REVIEW REPORT
HESTVATN PROJECT

by the
HARZA ENGINEERING COMPANY INTERNATIONAL

for
THE STATE ELECTRICITY AUTHORITY
ICELAND

SUMMARY LETTER

THE STATE ELECTRICITY AUTHORITY ICELAND		
HESTVATN PROJECT		
ESTIMATED ANNUAL CHARGES		
HARZA ENGINEERING COMPANY		
APPROVED: <i>C. K. Willey</i>		
CHICAGO, ILLINOIS	DATE Oct. 1961	DWG. NO. 279 P I

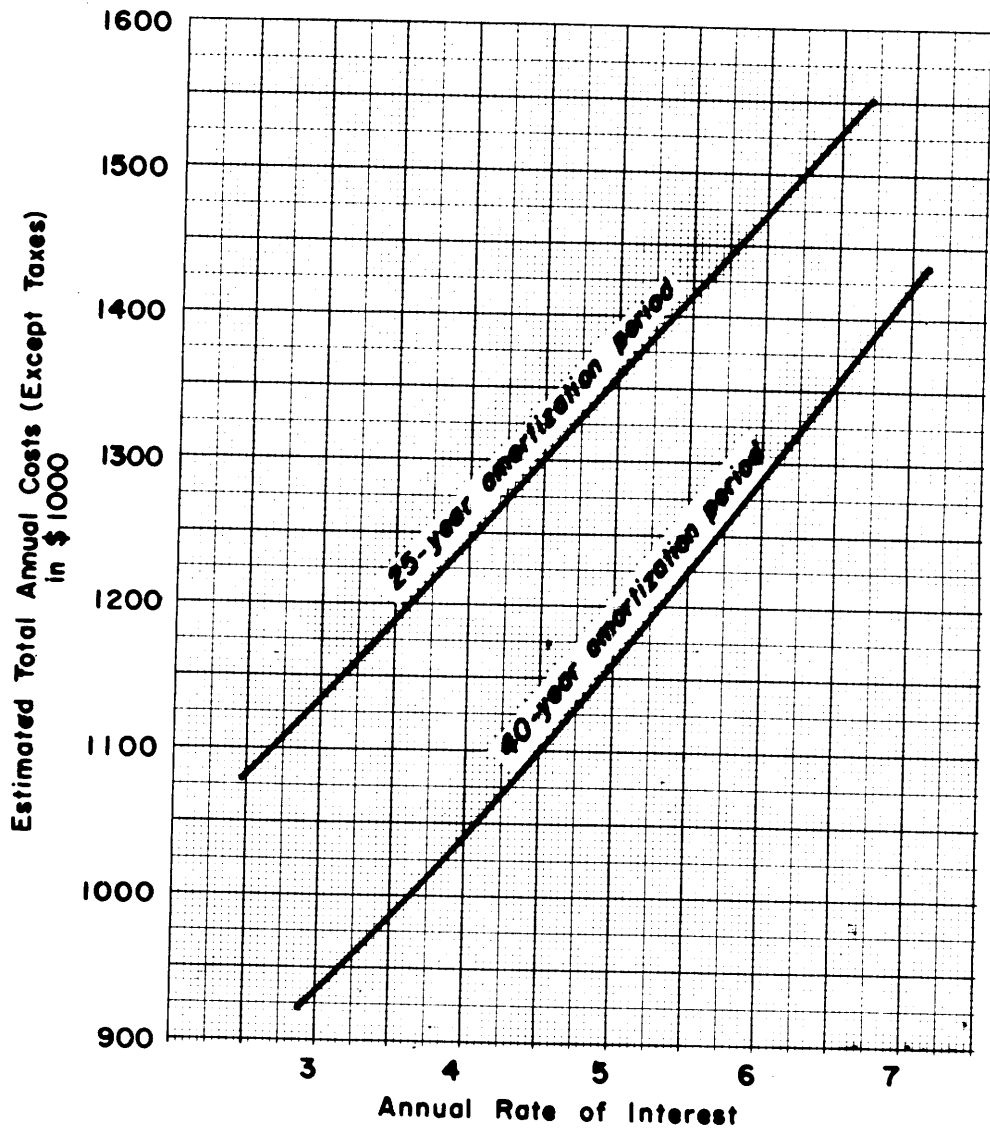
Interest and amortization service ordinarily represents the major portion of annual costs for a hydroelectric project and are dependent on financing terms which at the present time, are unknown. We therefore computed the debt service for several interest rates and for both 25 and 40-year amortization periods. The results are shown graphically on Exhibit 1. The values given by the curves include all estimated annual charges except taxes.

THE STATE ELECTRICITY AUTHORITY ICELAND		
HESTVATN PROJECT		
ESTIMATED COST OF ENERGY		
HARZA ENGINEERING COMPANY		
APPROVED	<i>C. F. W. Kelly</i>	
CHICAGO, ILLINOIS	DATE Oct 1961	DWG NO 279 P2

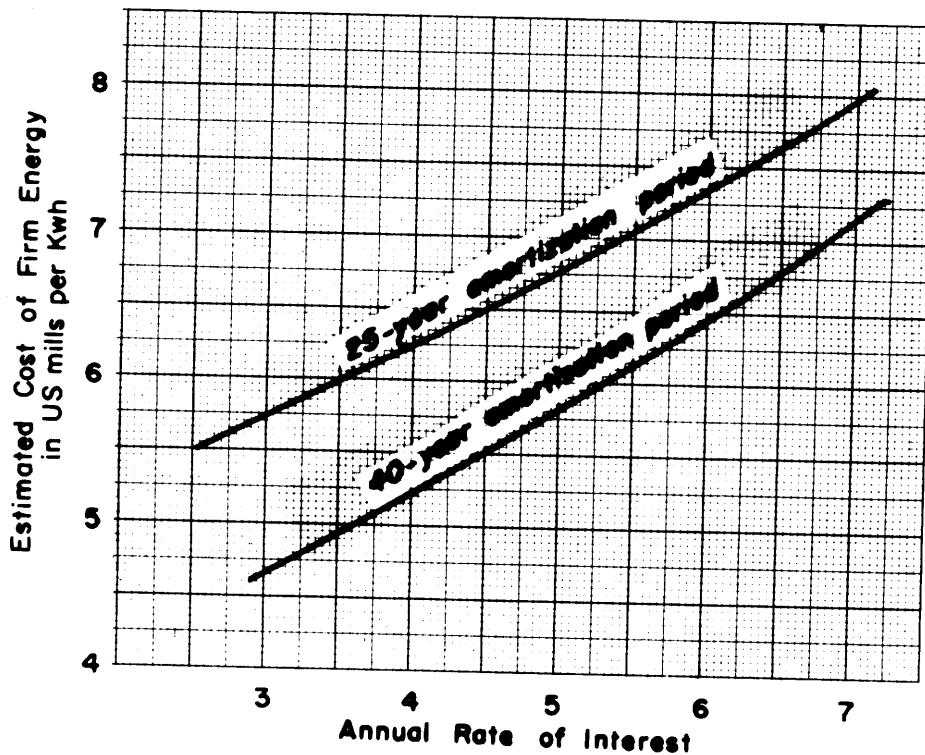
The estimated unit cost of firm energy is presented graphically on Exhibit 2 for a wide range of financing terms. We estimate that the cost of primary energy from the project will be from five to seven U.S. mills per kilowatt hour or 0.20 to 0.30 Icelandic Kroners for the most common range of interest rates.

The unit cost of energy is arrived at simply by dividing the annual charges with the amount of firm energy produced in a year. If we, as previously discussed, assume that 200 million kilowatt hours would be produced and delivered to the power system annually the cost of energy will be as shown graphically on Exhibit 2.

The curves show the cost of energy delivered on the low tension side at Ellidaar for interest rates ranging from three to seven percent and for amortization periods of 25 and 40 years. Taxes that may be levied on the operation of the power plant are not included in the estimated unit cost of energy.

For most common financing terms, the cost of firm energy will be between five and seven mills (U.S.) per kilowatthour. With an interest rate of five percent and 40 years amortization, the cost will be about six mills per kilowatthour. If the project could be exempt from import duties and taxes, the cost of energy would be reduced by about one mill. The value of the secondary energy that may be produced can not be predicted with any reasonable certainty at this time. We estimate that the crediting of income from the sale of secondary energy to the annual costs would result in decreasing the estimated unit cost of primary energy by two-tenths of one mill for each mill per kilowatthour received from the sale of secondary energy.

THE STATE ELECTRICITY AUTHORITY ICELAND
HESTVATN PROJECT
DIVERSION CANAL PLAN AND SECTIONS
HARZA ENGINEERING COMPANY APPROVED Oct. 1961
CHICAGO, ILLINOIS
Drawn by: [Signature] Scale No. 279 P 4

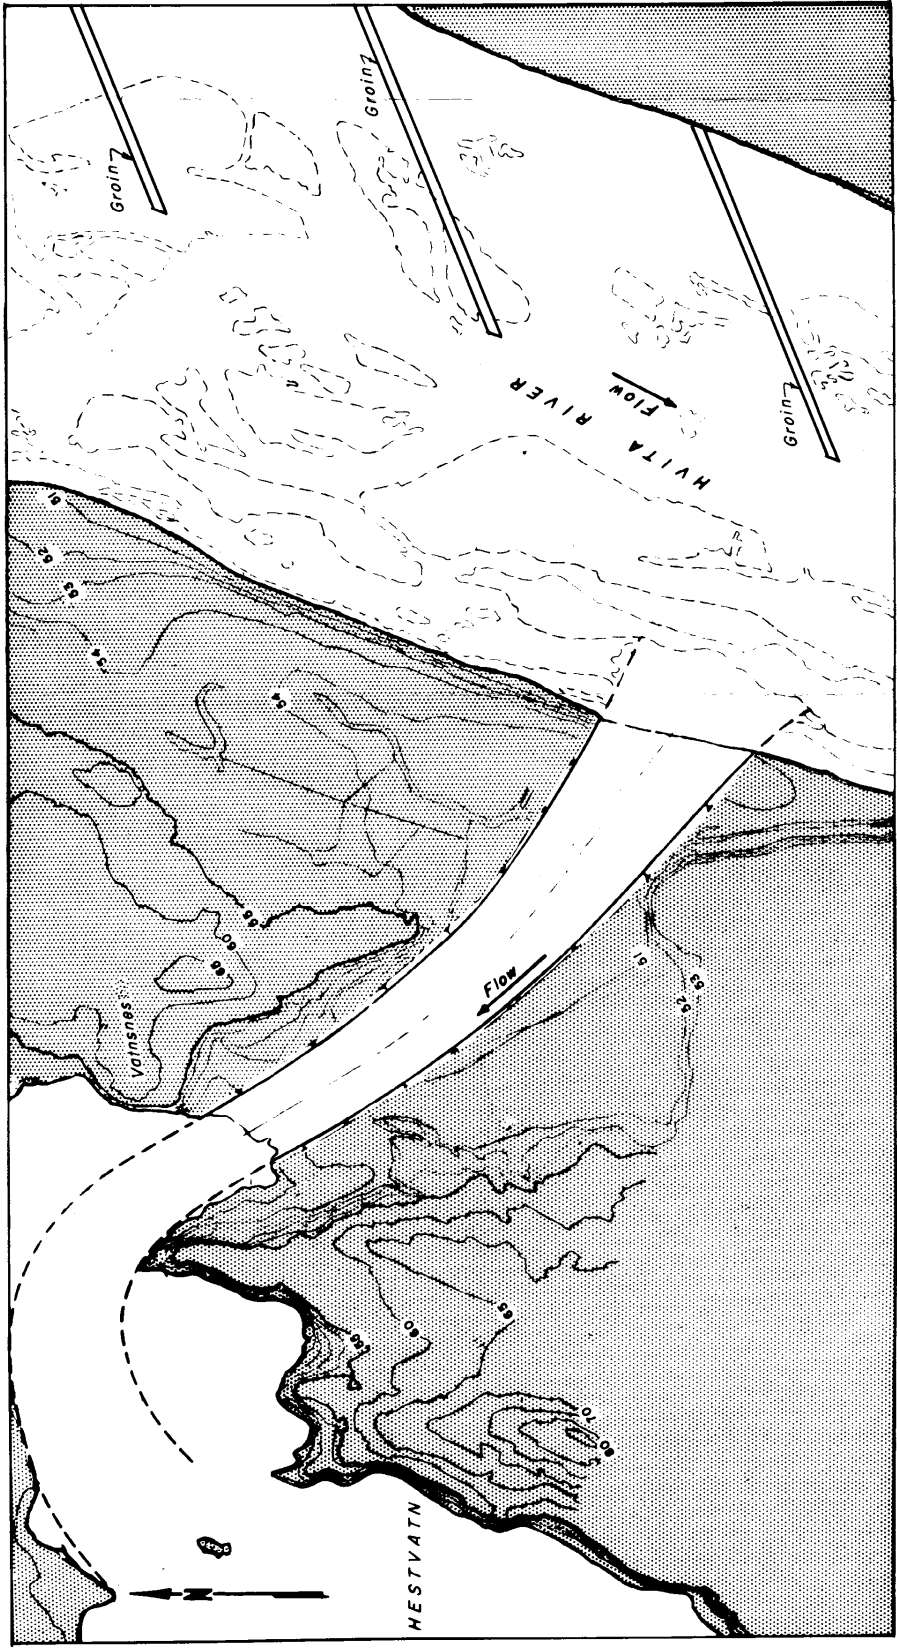
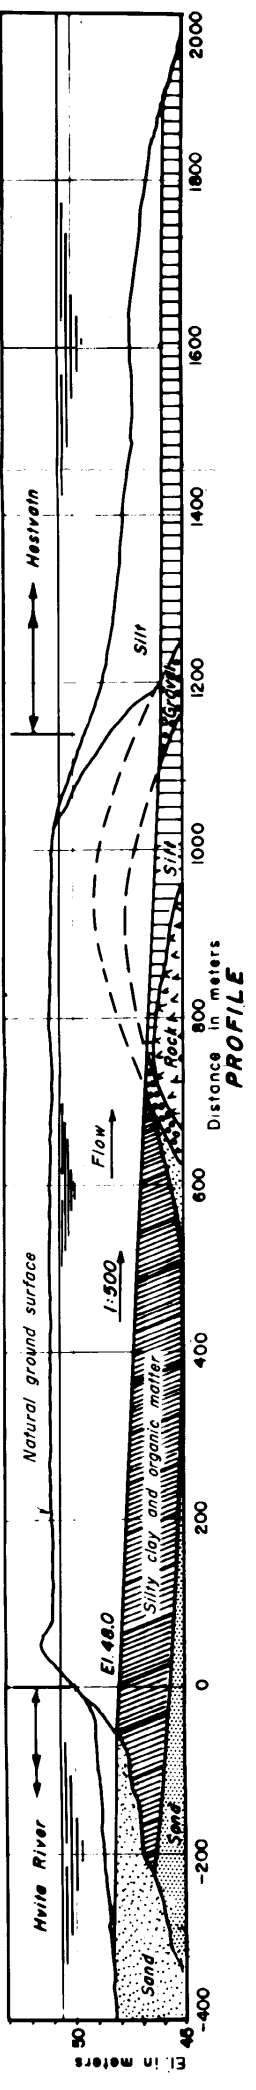
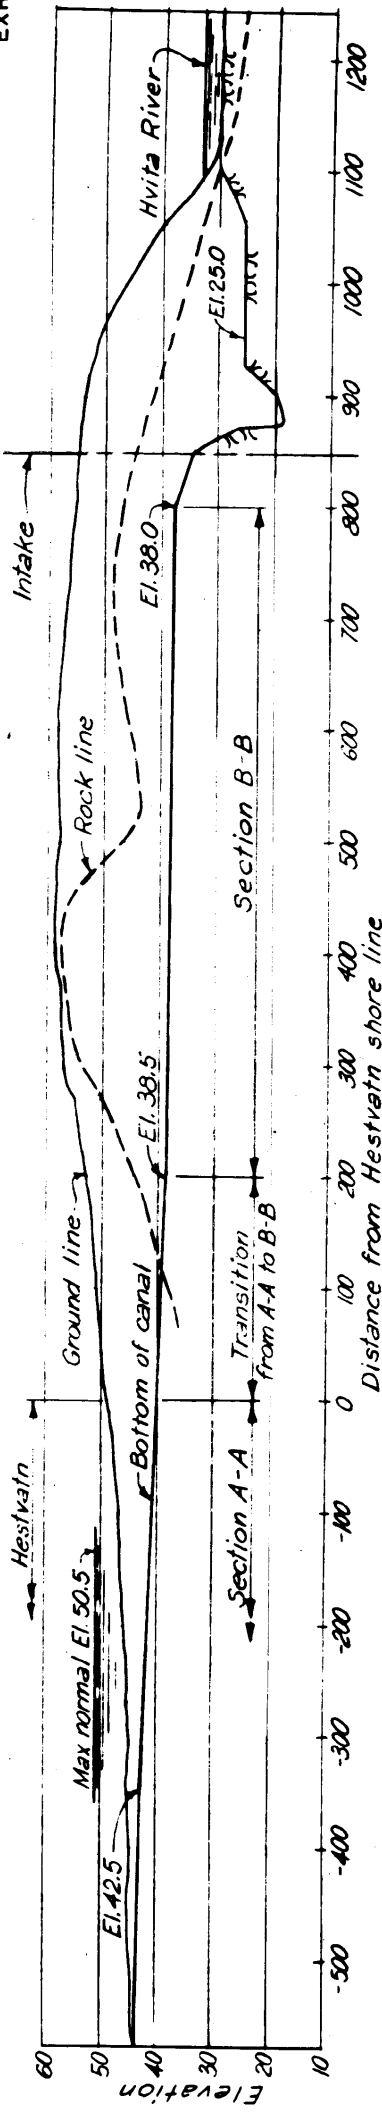
Diversion Canal. On the basis of a careful study of all available data we believe that the location of the canal should be approximately as shown by Thoroddsen for his Alternative 1. This route would require the least amount of excavation and would probably be superior to any other alignment as regards operation.

At the present time, however, the deep channel of the Hvita River is near the left bank whereas the right side of the river is quite shallow as a result of sediment deposits. It is desirable that this condition be reversed in order to improve the entrance conditions to the canal. This may be achieved by groins suitably placed from the left bank of the river. The groins will force the main flow towards the opposite bank and cause an increase in the velocities. The resulting erosion will probably lower the riverbed to about the same level as presently along the left bank, or about elevation 47.0. The canalization of the river should extend at least as far upstream as Hamrar and quite possibly one or two kilometers farther. Hydraulic model tests will be required in the final design to determine the best location of the groins. For the purposes of this review we have assumed that a total of six groins, each about 500 meter long, will be required. The top of the groins were assumed at elevation 51.0.

With canalization of the river as outlined we believe that the bottom of the canal at the entrance should be between elevation 47.0 and 48.0. Since the higher elevation will give the most conservative cost estimate, elevation 48.0 was assumed for the purposes of this review. A profile of the canal is shown on Exhibit 4. The canal is designed with a constant slope down towards Hestvatn where the bottom will be at elevation 46.0. From a width of about 250 meters at the entrance, the canal narrows to about 125 meters in the deeper section at the outlet into Hestvatn. Dredging of the lake at Vatnsnes will be required to provide adequate waterway into the deeper parts of the lake.

The canal will be about 1100 meters long and will require about 725,000 cubic meters of excavation. In addition, about 320,000 cubic meters must be removed by dredging in the Hvita riverbed and in Hestvatn near Vatnsnes. The headloss in the canal will be negligible.

NOTE
Position of grains subject to further study, possibly by model tests

HEADRACE AND TAILRACE
PROFILES AND SECTIONS

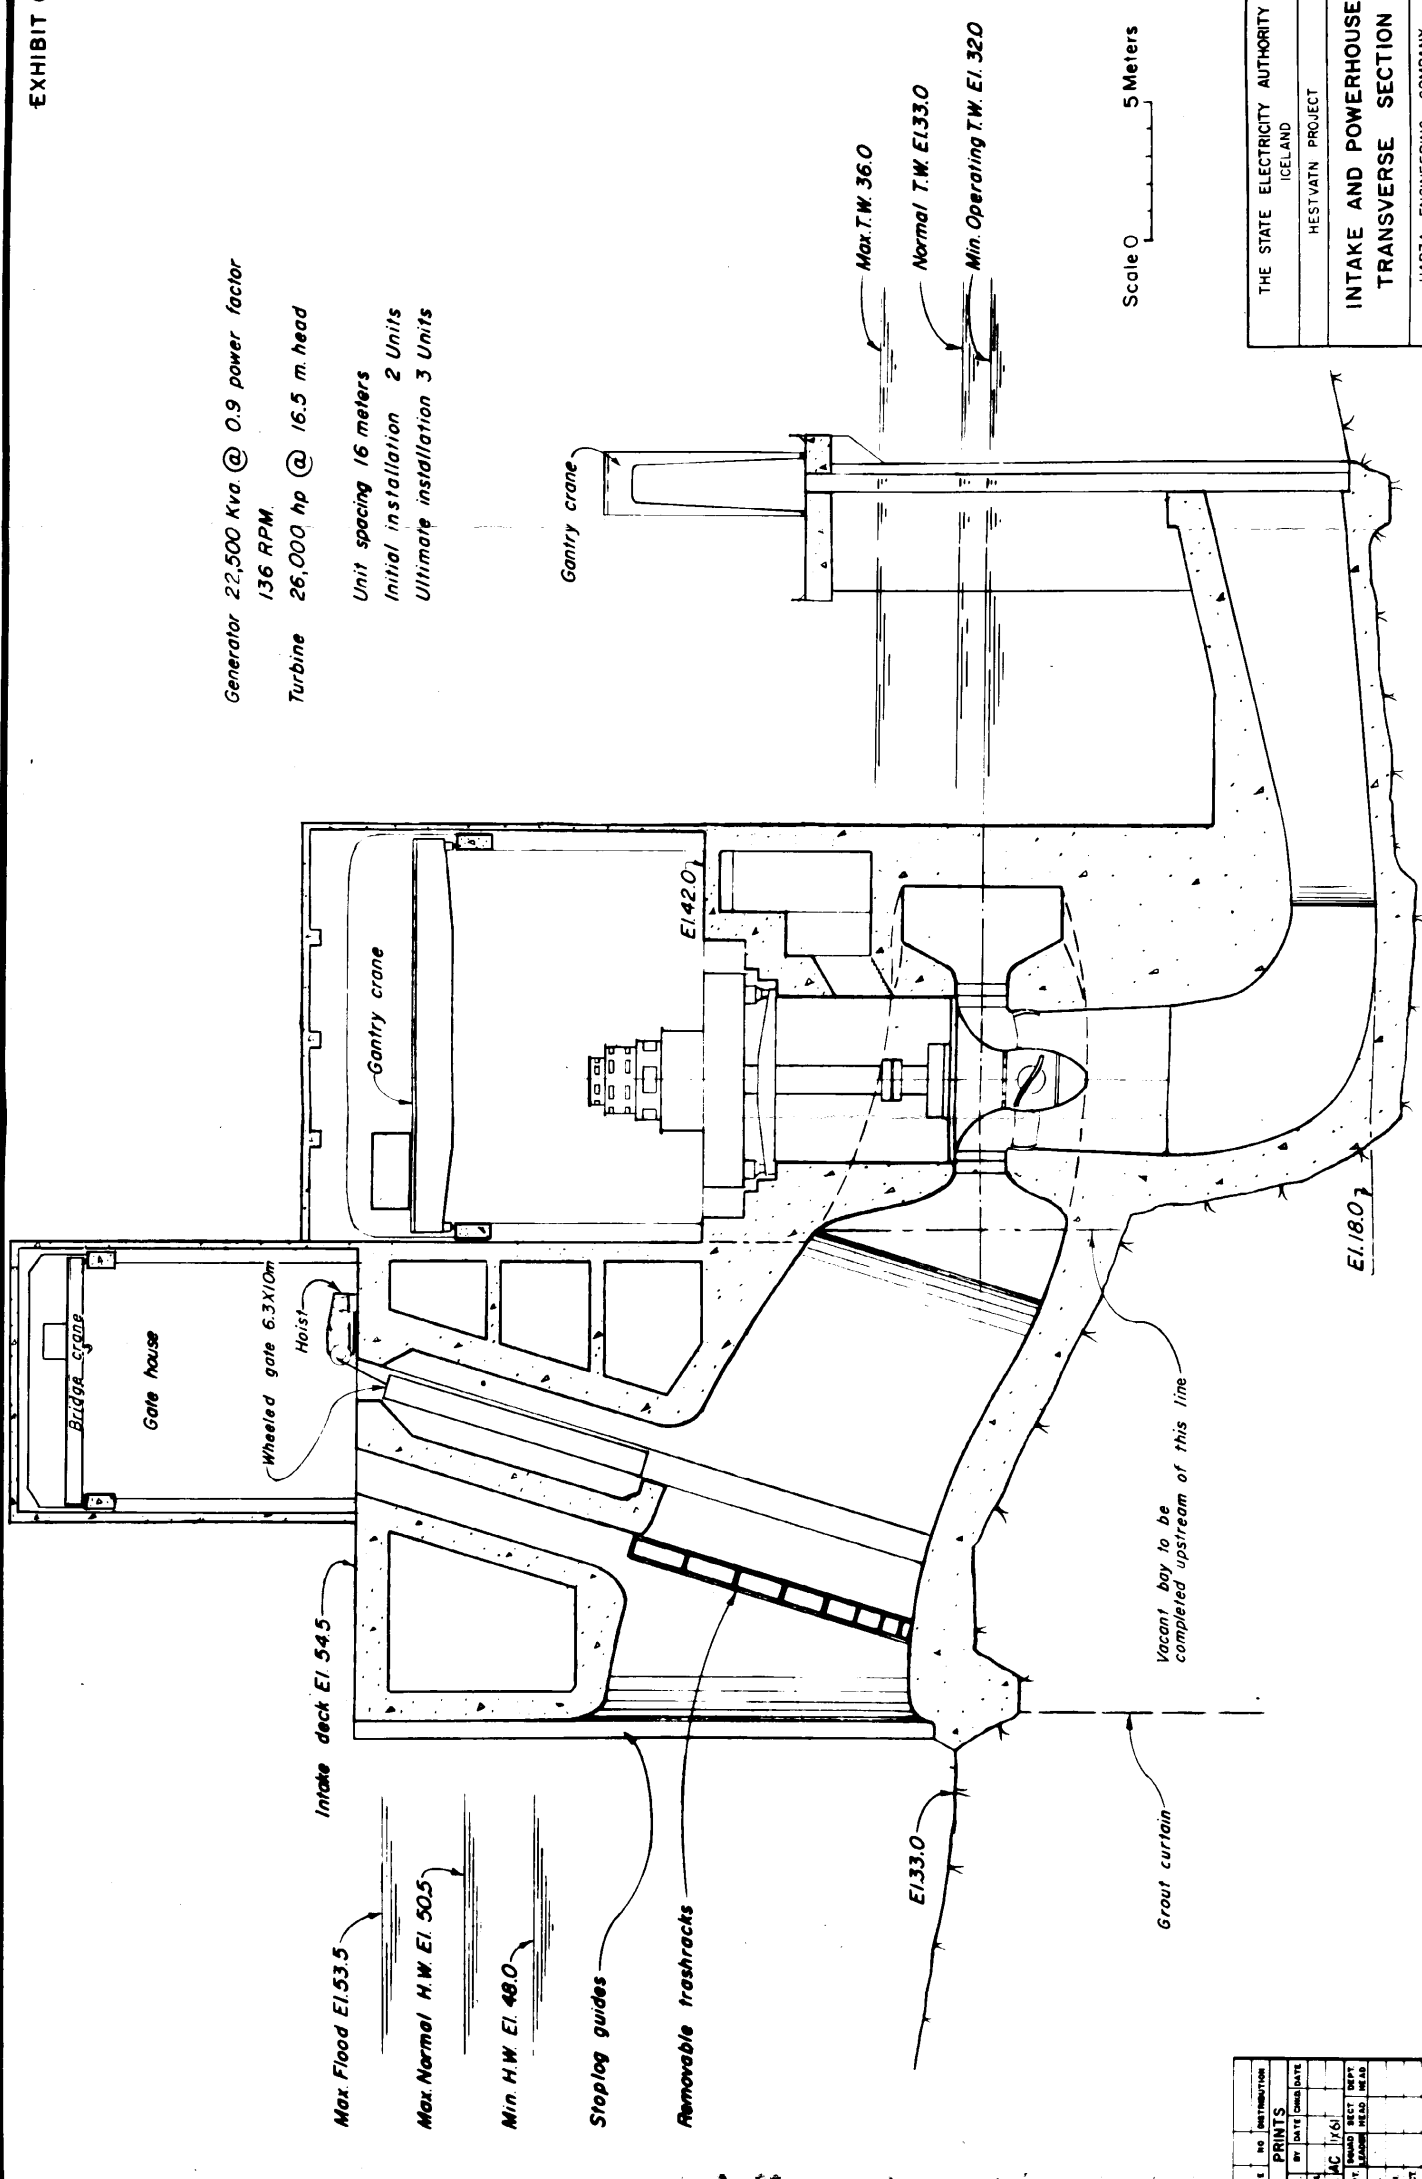
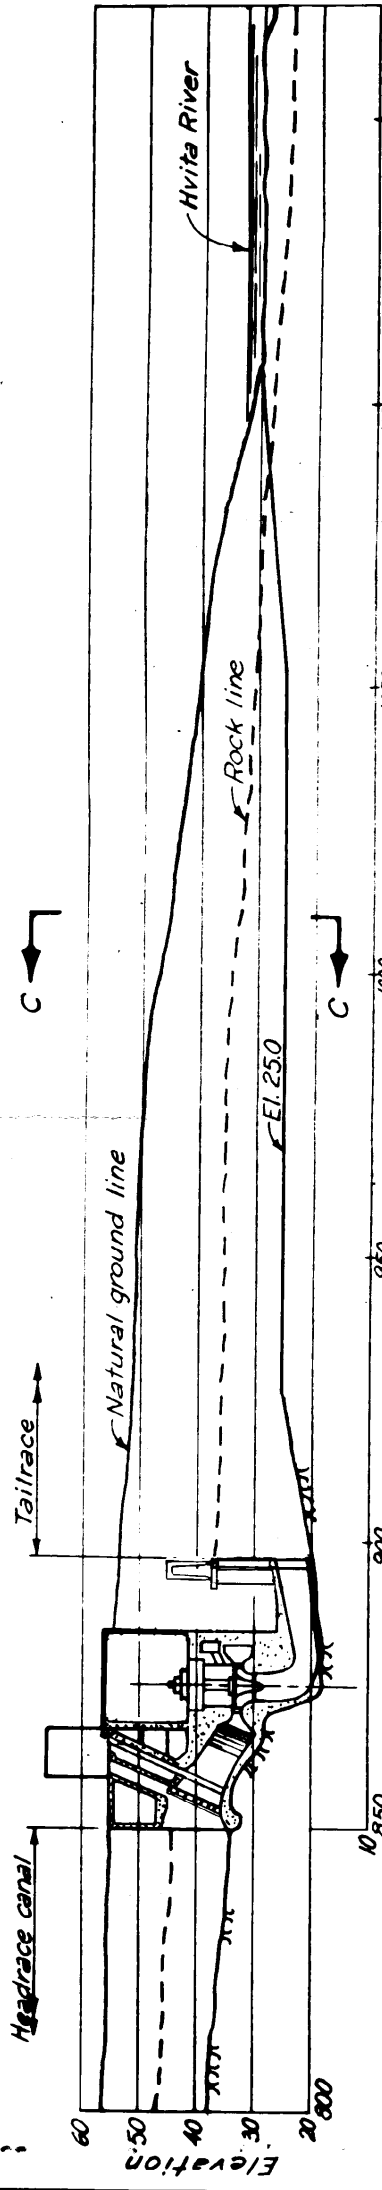
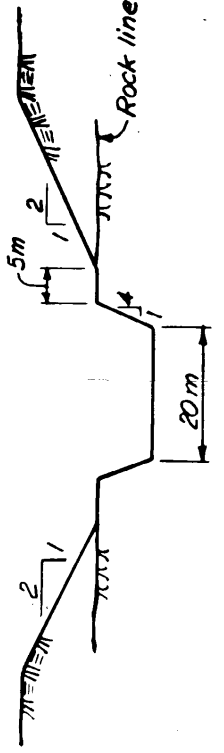
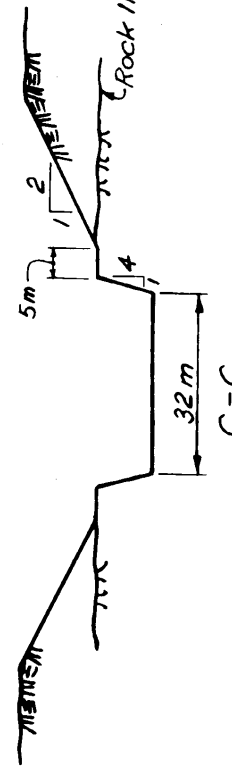
A section through a proposed arrangement of the intake, powerhouse and tailrace is shown on Exhibit 6. The principal difference between this layout and the one shown in the Project Plan Report is in the intake arrangement where we propose to use wheel gates instead of tainter gates. This will shorten the intake considerably and will also permit the construction of a center pier in each bay which will reduce the stresses greatly and thus the amount of reinforcement required. The trashracks will be well below the minimum operating level and will be made removable. The intakes can be closed off by a stop log arrangement at the nose of the piers.

As previously indicated, we do not believe that an ice outlet is needed. For the third unit we propose therefore that a skeleton intake bay be constructed initially.

The required stability could be provided by anchors into rock. The stability could also be improved by filling the enclosed space underneath the intake deck with rock as this space is not utilized for any other specific purpose.

The top of the intake is at elevation 54.5 which will provide one meter of freeboard above the design flood level. This should be ample in view of the very wide escape route the floodwater will have east of the Diversion Dam at this level. The intake deck will also serve as a road access across the headrace. The gate hoists will be housed in a gatehouse that may be heated with air from the powerhouse.

We propose to make the tailrace channel slightly shallower but wider than shown in the Project Plan Report. We believe that this will improve the hydraulic efficiency on the basis of natural tailwater conditions and would also be more convenient from the construction viewpoint, thus less costly.
